Plan Change Request

➤ Specify the approved civil plans affected: C5-101, C5-201, C5-202, C5-201, C6-101, C6-201

Project:
**WSF Gold Gate
 Redevelopment**
 Civil Construction
 Permit

WATER & SEWER VENDOR CONNECTION
DETAIL A
1" = 1" C6-201

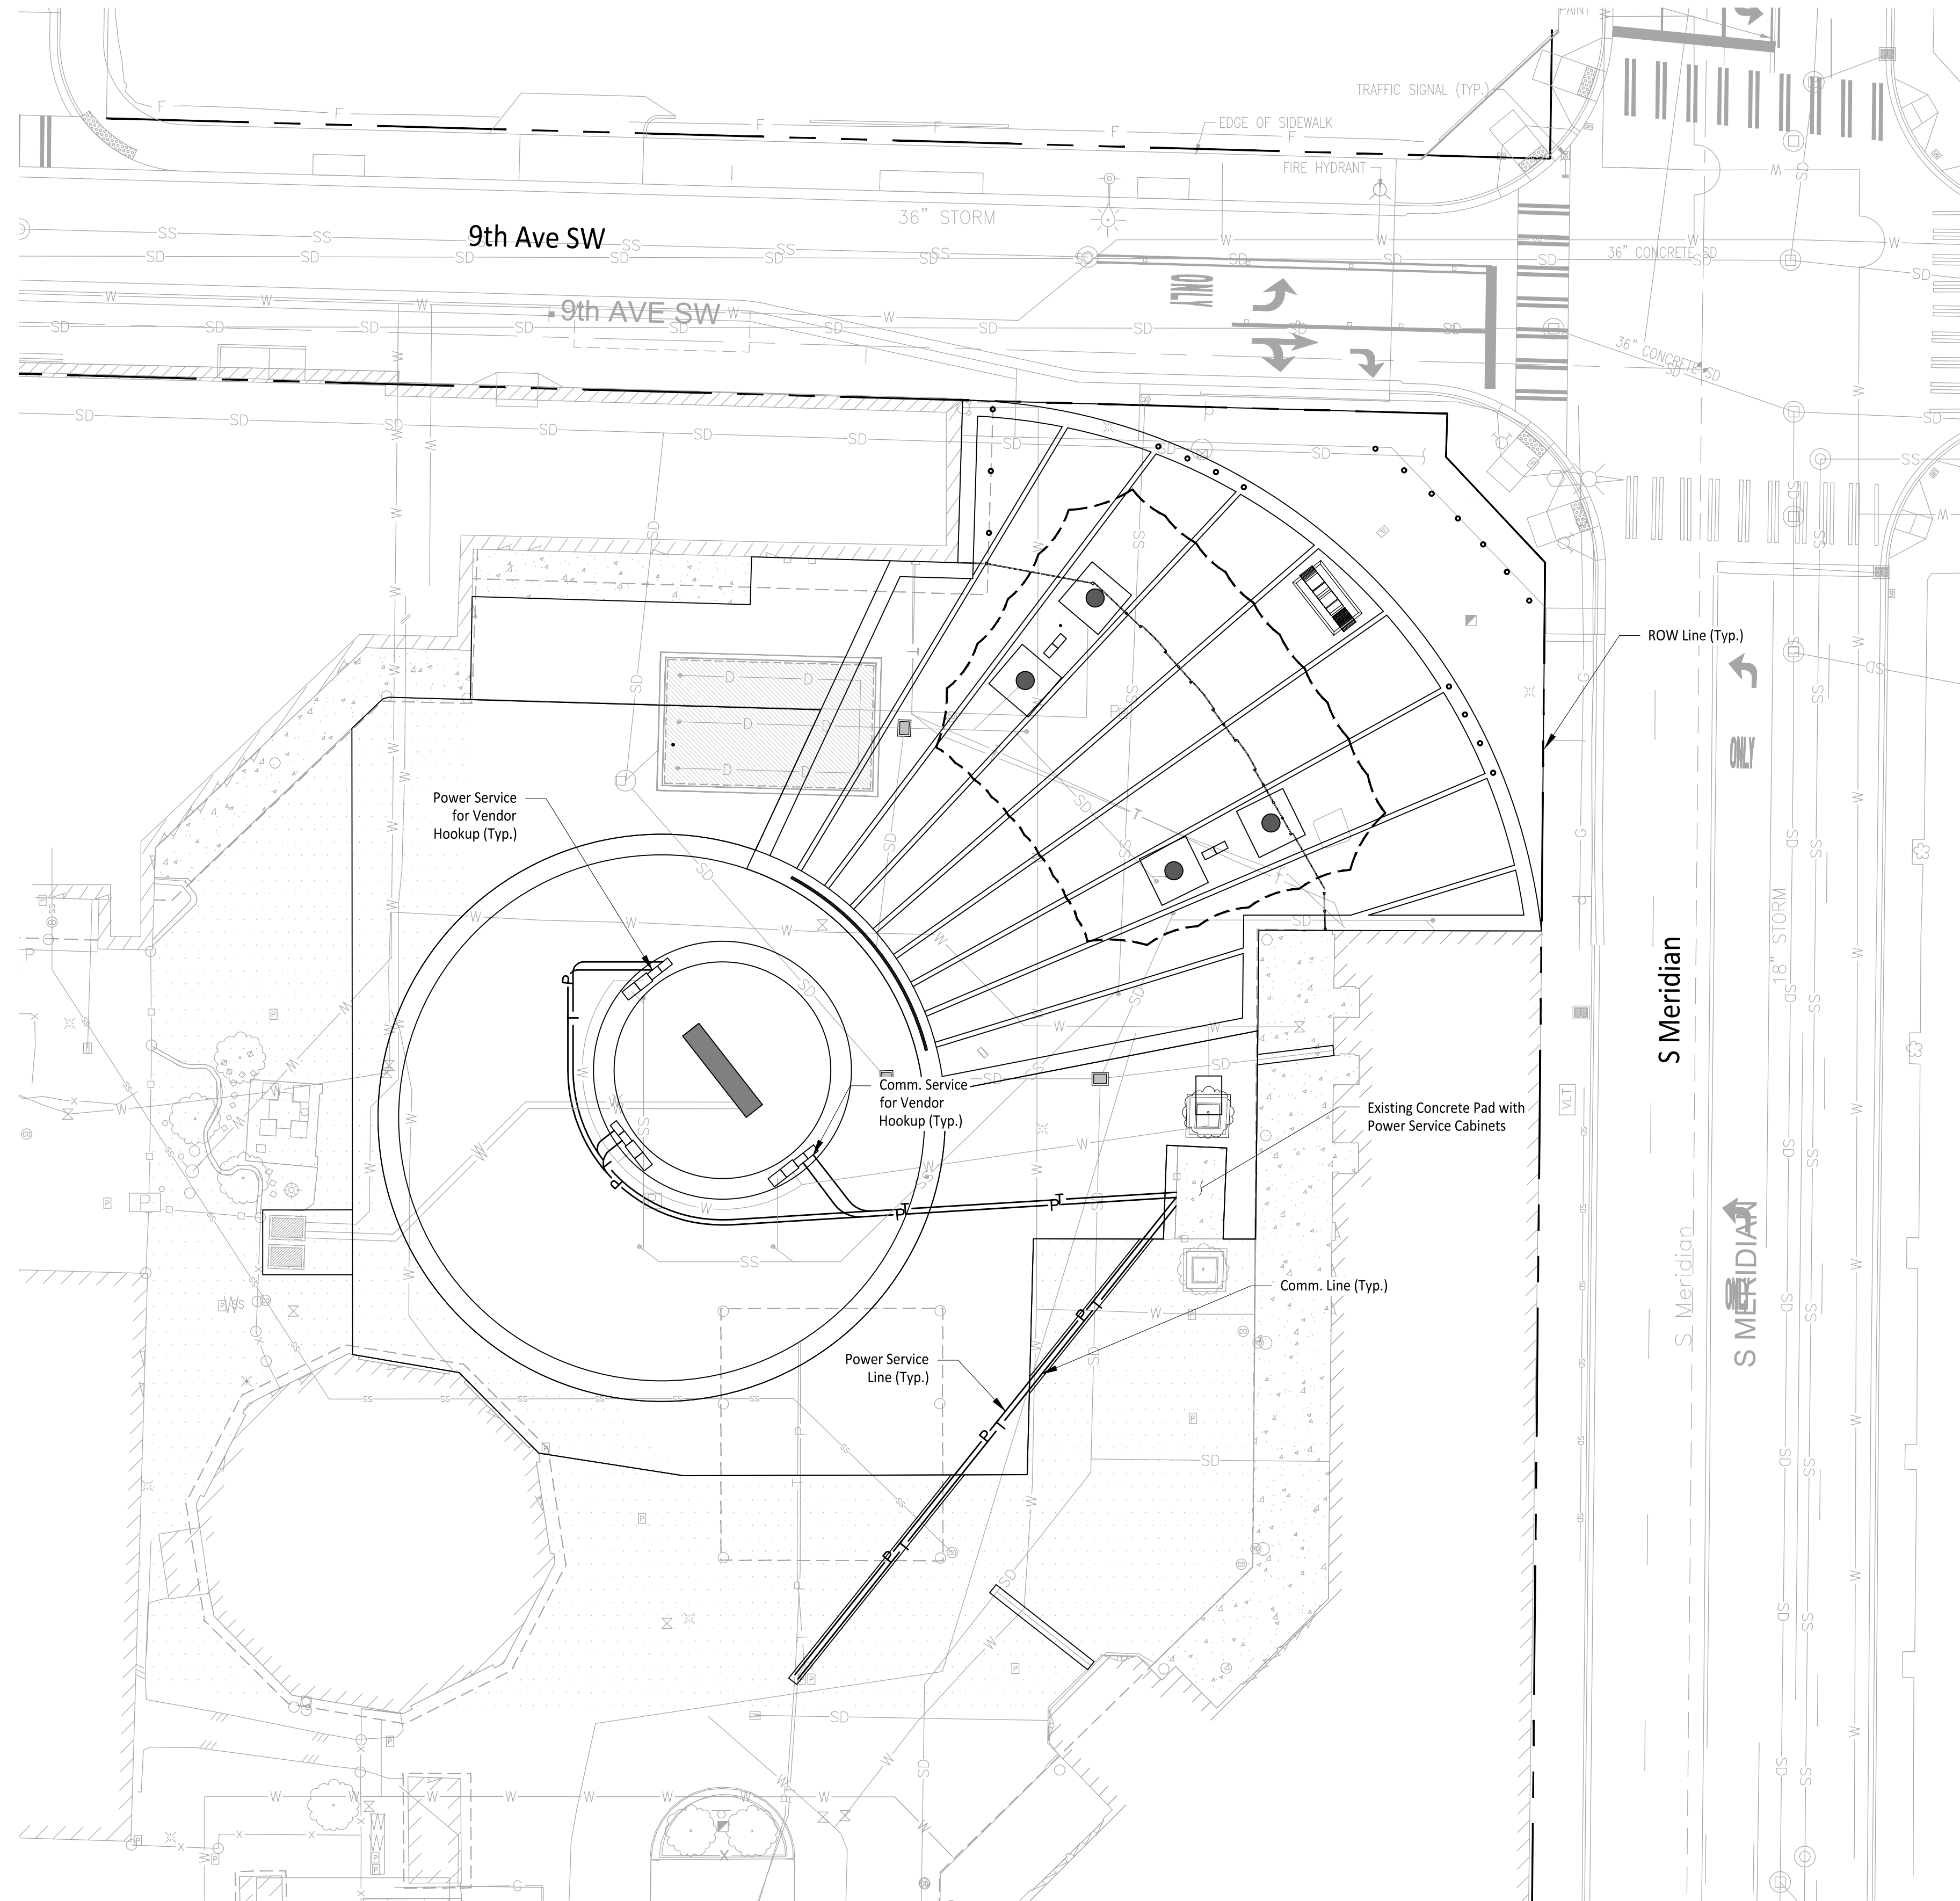
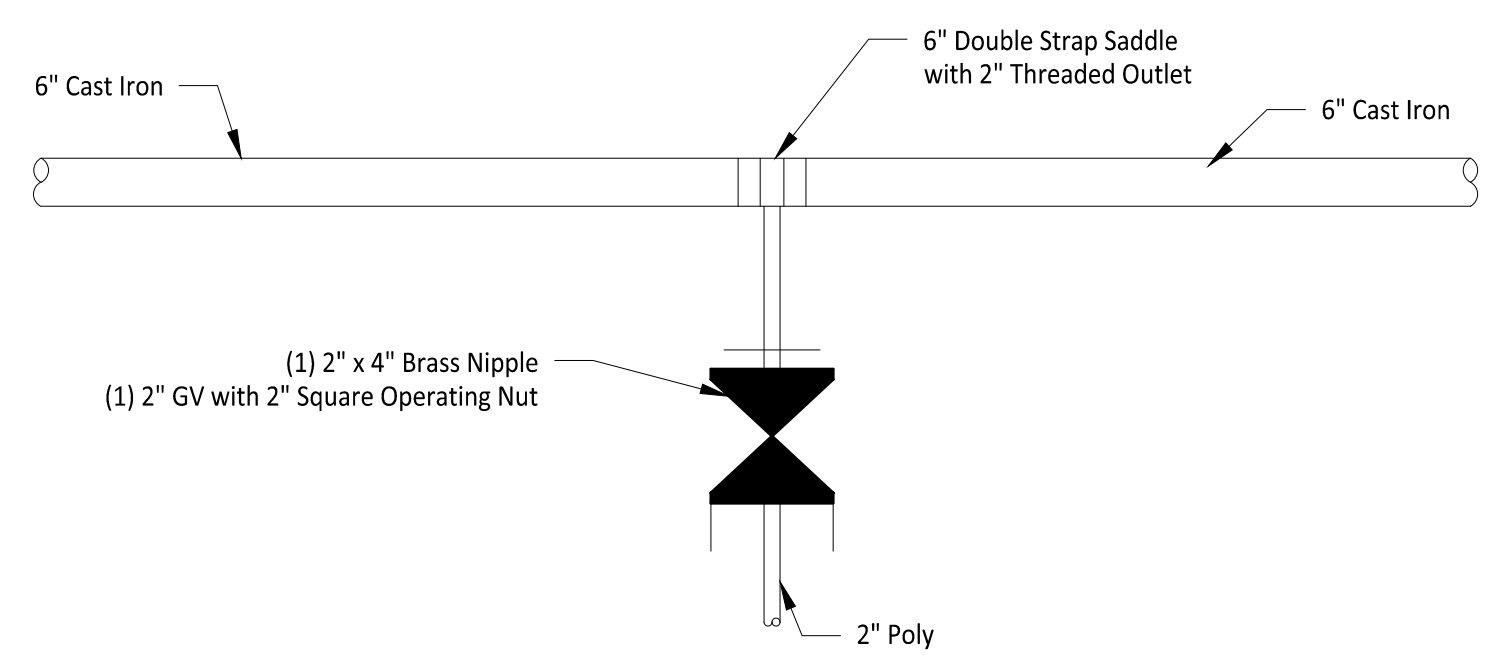
A new fountain structure and 4 vendor hookups (Sewer, Water, Power, Comm.) will be installed. The fountain will be permitted under a separate permit. A water connection will be made from the previously installed water stub to the proposed fountain mechanical vault. In addition, a new pre-built sewer lift station will be installed that will pump the fountain overflow/flushed water and vendor hookup discharge to a previously installed force main that connects out to a side sewer along 9th Ave SW.

- WATER VAULT**
- SEWER VAULT**
- NOTES**
- Hose bibs and sewer connections to be no more than 6" below vault lid.
 - Water vault lid to have two inch hole above hose bib.
 - Sewer vault lid to have four-inch hole directly above 2" to 4" PVC reducer.
 - Vault to be Type 3 22" by 32" with one 12" riser and one diamond plate double hinged H20 rated lid.
 - Bottom of vault to be backfilled with pea gravel.
 - All pipe clamps to be stainless steel.

DWG. No. **C7-101**
27 OF 27

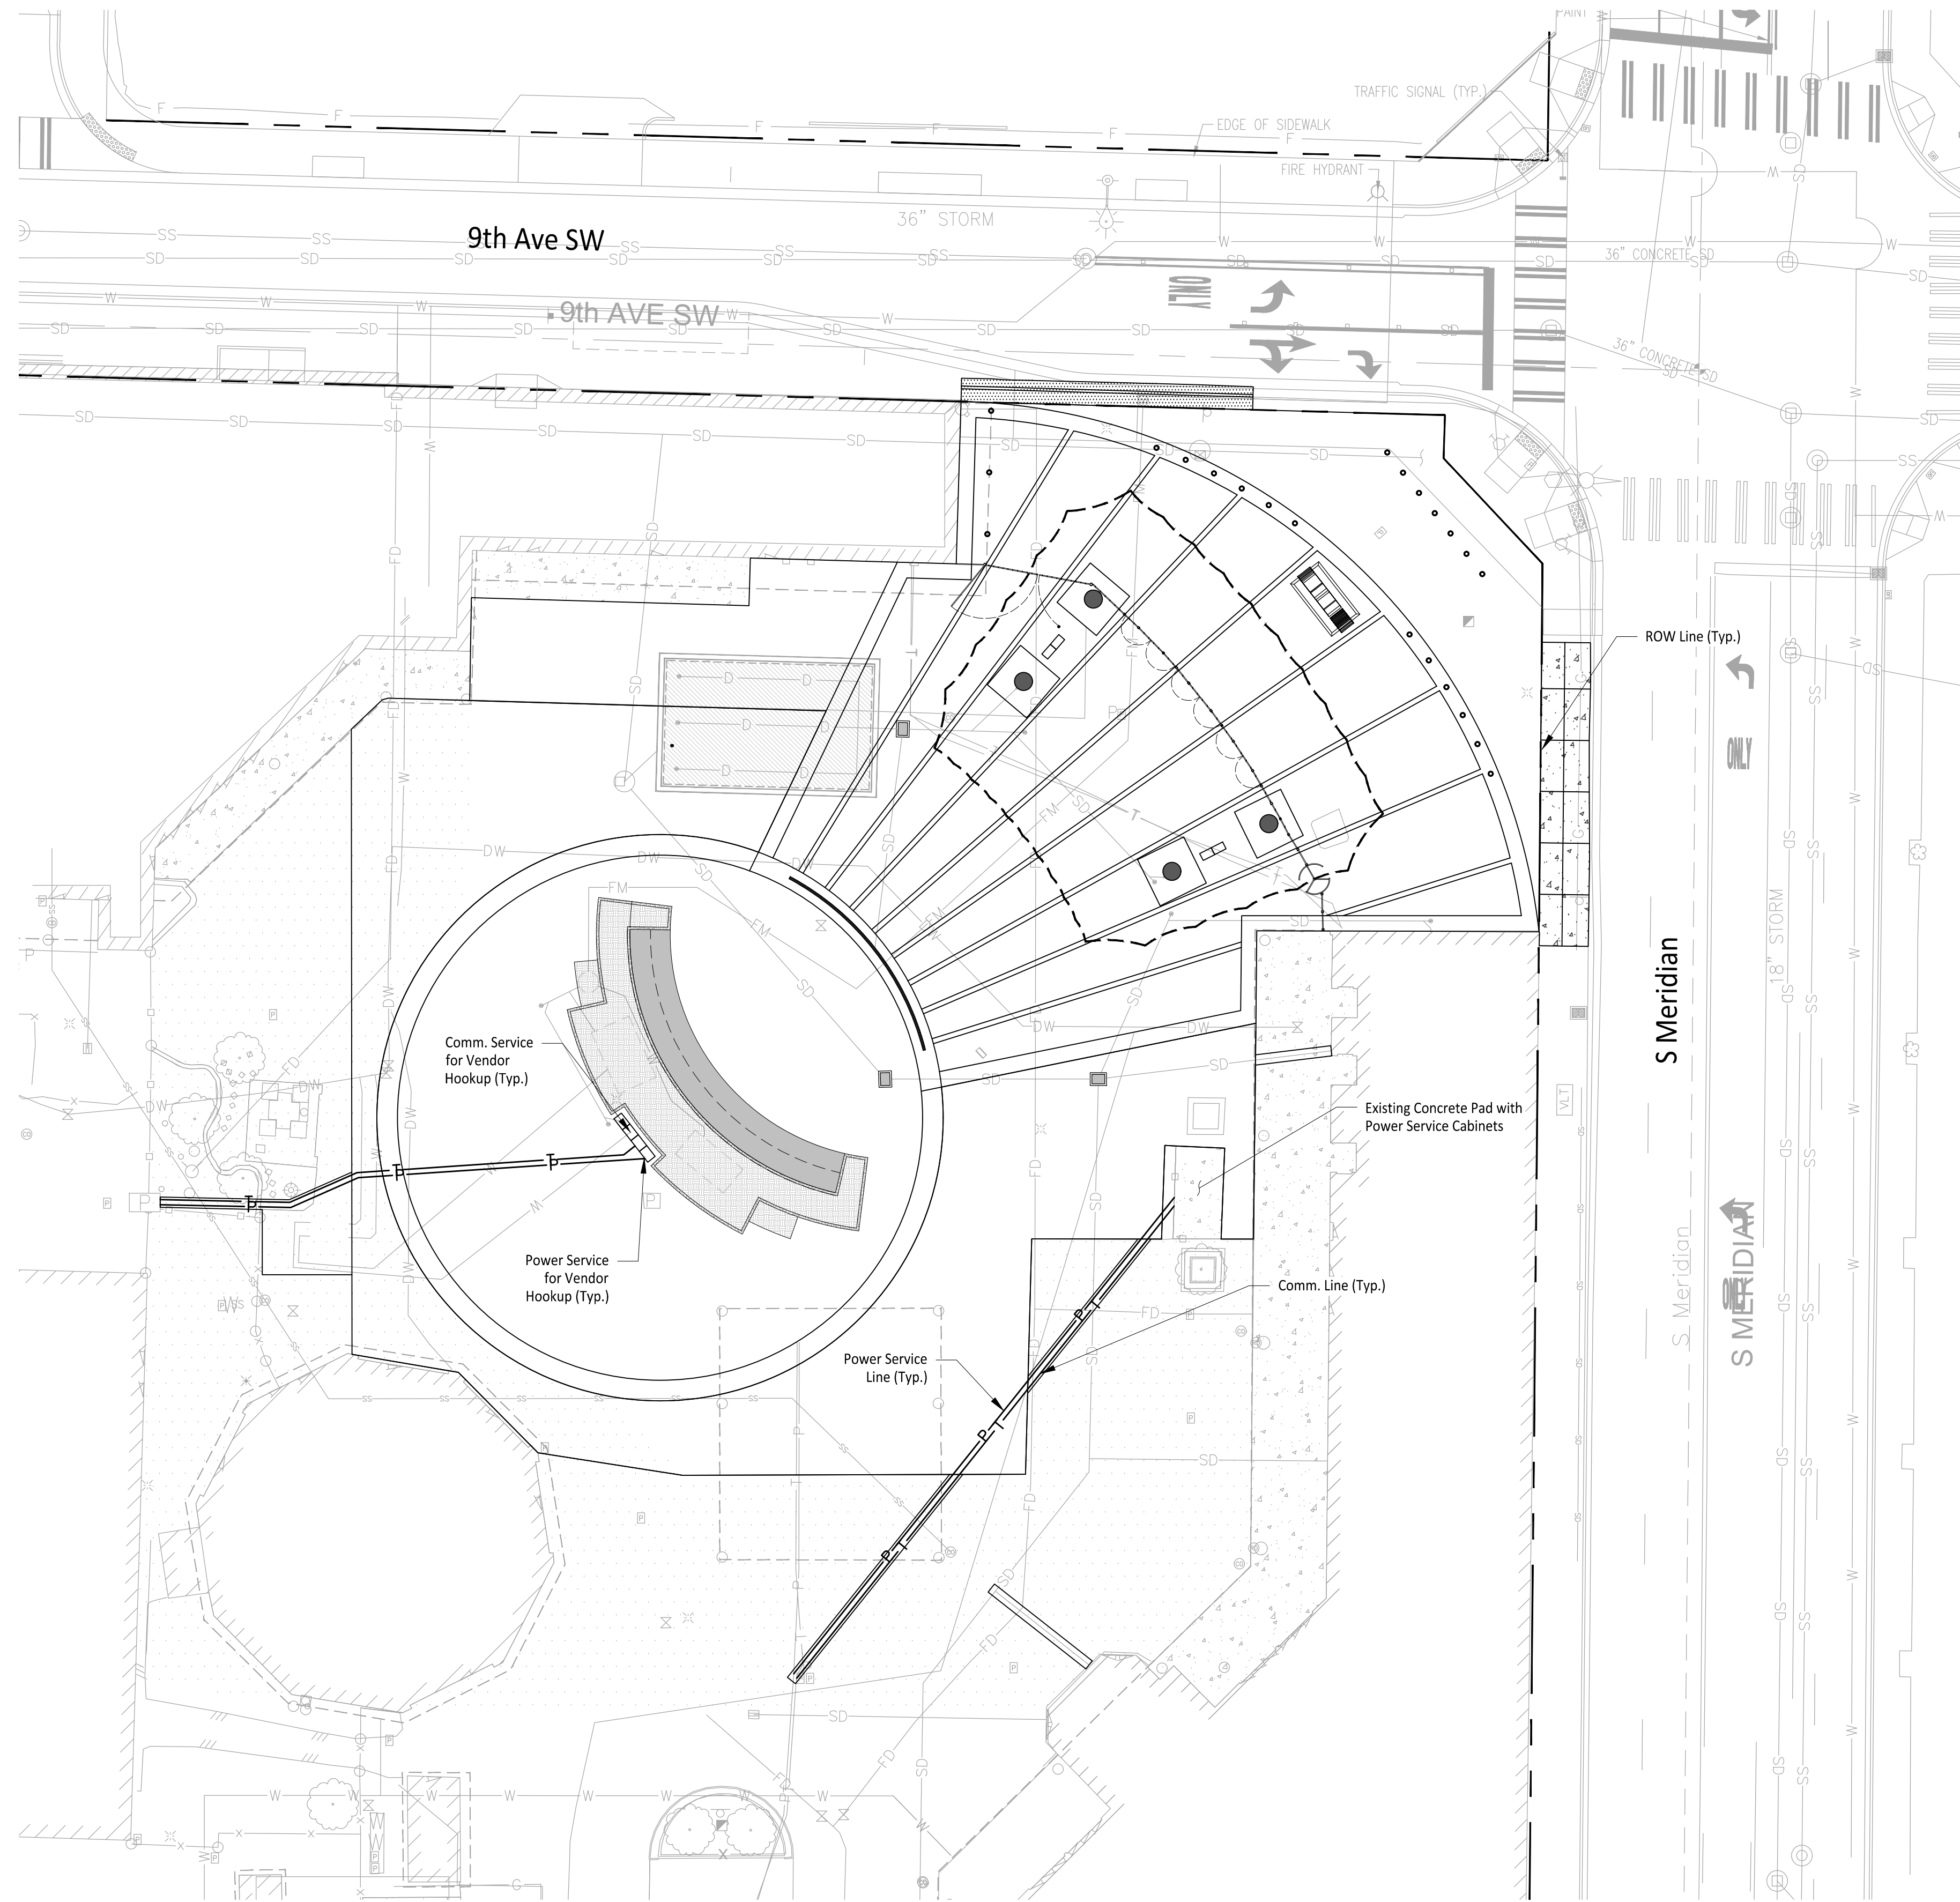
1. Proposed Power Services to be served from Existing Vaults on-site. Service Lines to maintain minimum 3' of cover from finish grade.
 - 1.1. Proposed Power Service = 415 LF.
2. Communication Data lines to be served from Existing Communication lines on-site. Communications lines to maintain minimum of 2' of cover from finish grade.
 - 2.1. Proposed Communication Lines = 405 LF.
